Figure C6.14.2.8.1—Effective Width of Gusset Plate

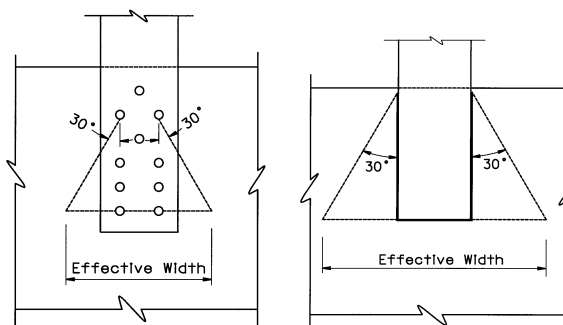
The nominal resistance of a gusset plate shall be based on the effective width as shown in Figure C6.14.2.8.1-1. The gross and net cross-section area shall be on the effective width.

Figure C6.14.2.8.1-1 shows the effective width for a gusset plate in accordance with Whitmore's method (Whitmore 1952).

Figure C6.14.2.8.4-1—Gusset Plate Connection

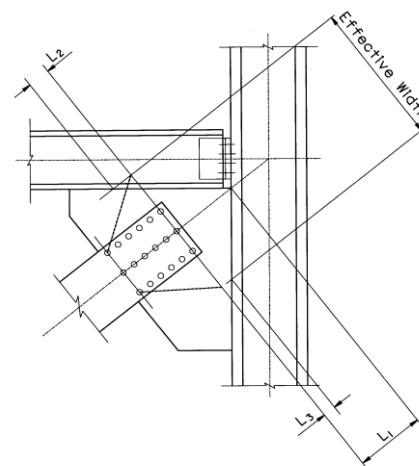
The effective length factor, K in Eqs. (6.9.4.1-1) and (6.9.4.1-2) may be taken as 0.6 for the gusset supported by both edges, and 1.2 for the gusset supported by one edge only (AISC 2001); A_e is the average effective cross section area defined by Whitmore's method; l is the perpendicular distance from the Whitmore section to the interior corner of the gusset. For members that are not perpendicular to each other as shown in Figure C6.14.2.8.4-1 (AISC 2001), l can be alternatively determined as the average value of

$$l = \frac{L_1 + L_2 + L_3}{3} \quad \text{(C6.14.2.8.4-1)}$$
